ADDENDUM NO. 2 TO PROJECT NO. 44867

**CONSTRUCTION, HVAC, PLUMBING AND ELECTRICAL WORK
ADDITION TO DEMENTIA UNIT, MONTROSE VETERANS HOME
2090 ALBANY POST ROAD
MONTROSE, NY 10548**

December 23, 2013

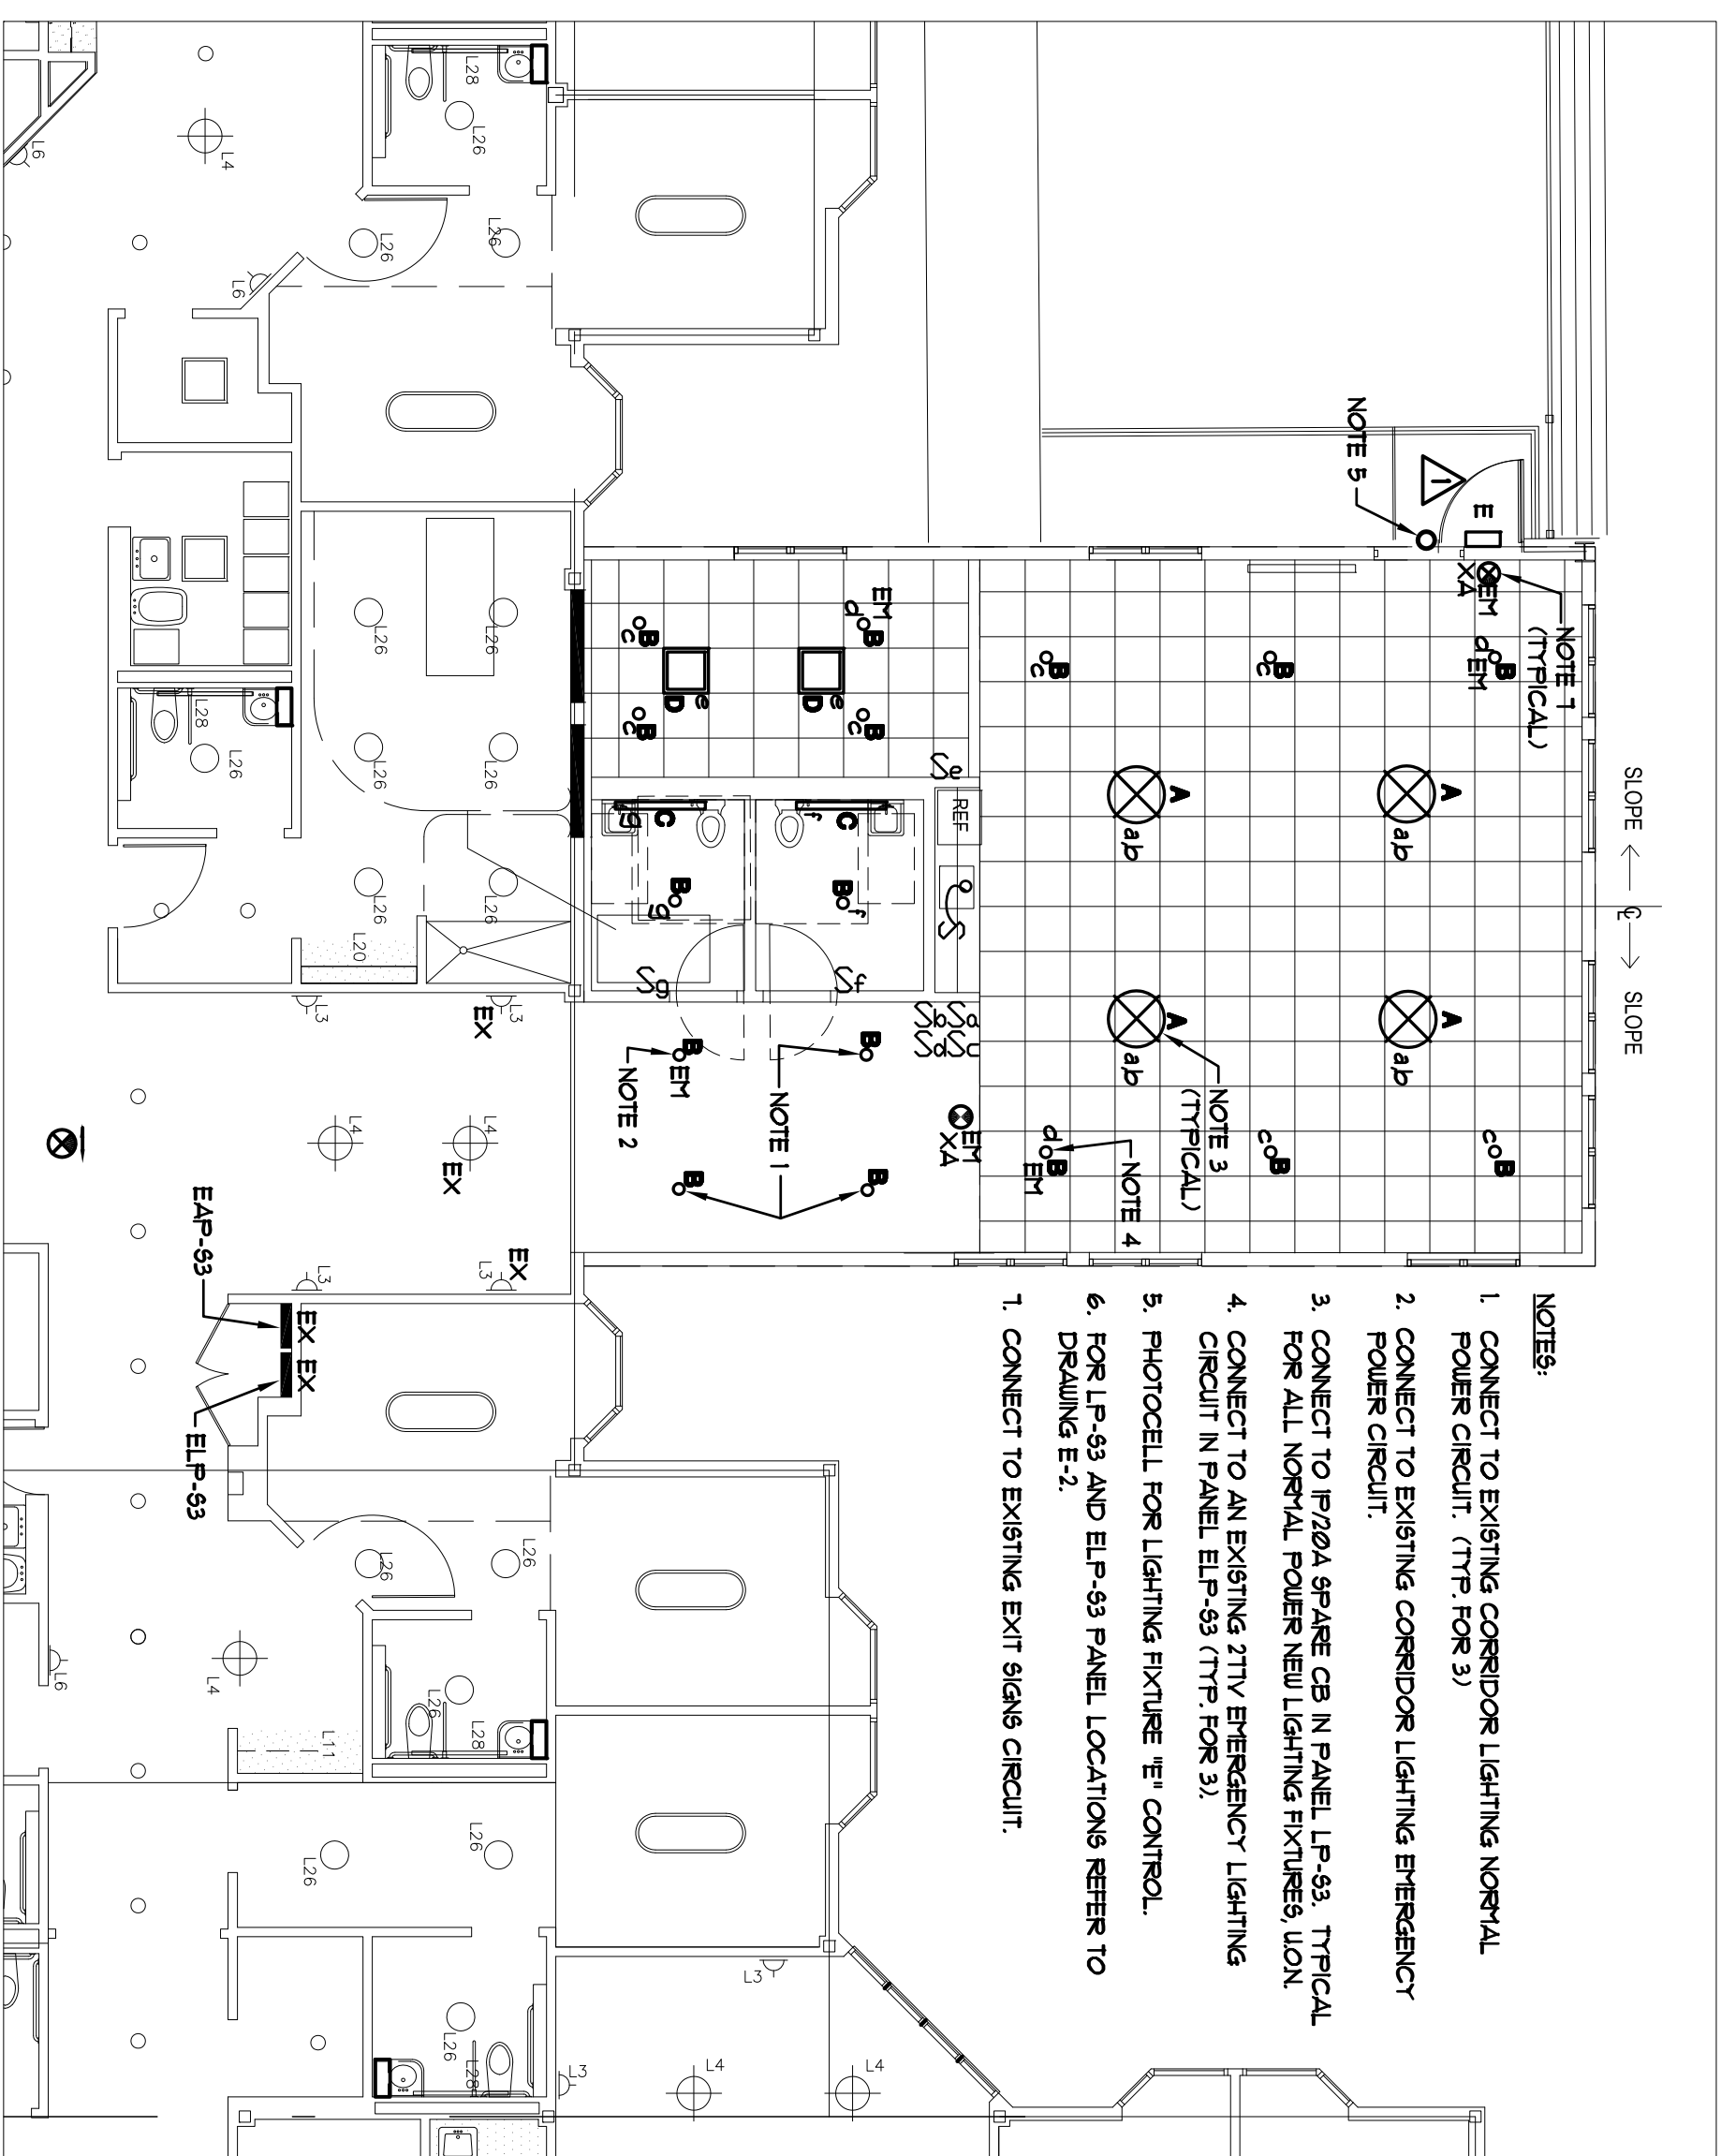
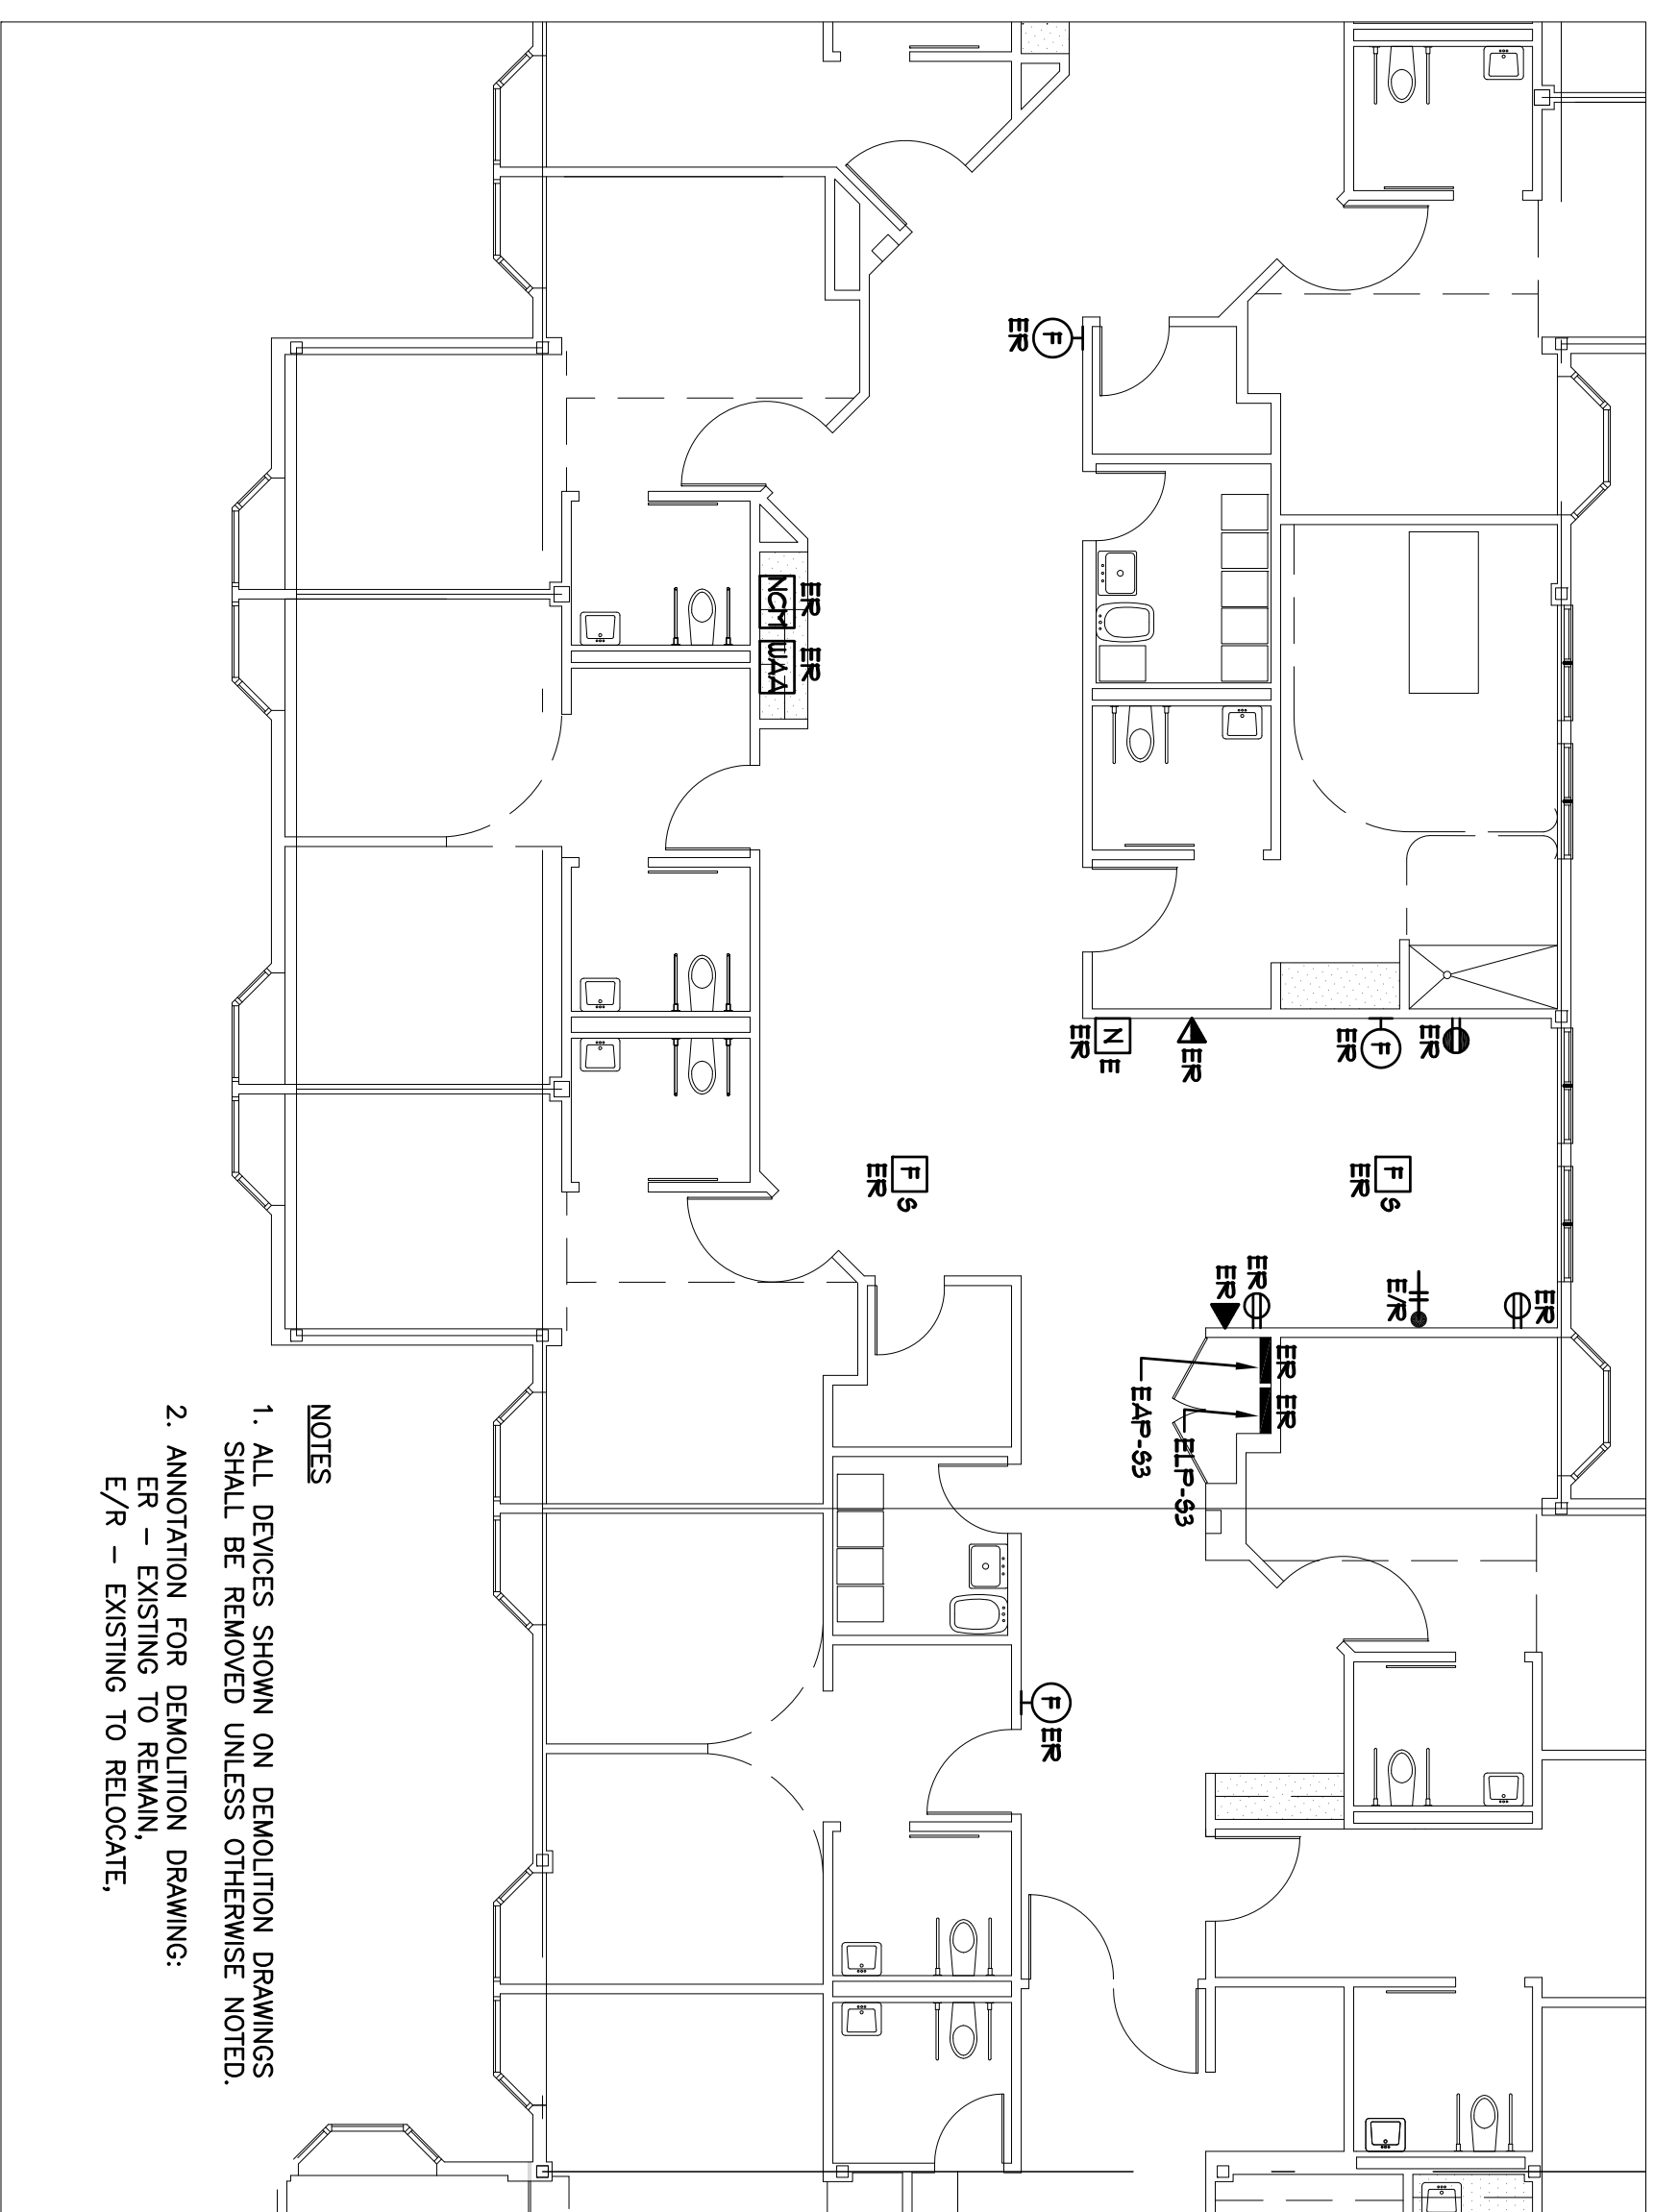
- a. Drawings Nos. E-2 and E-3, both noted “ADDENDUM 12/20/2013” accompany this Addendum and supersede the same numbered originally issued drawings.
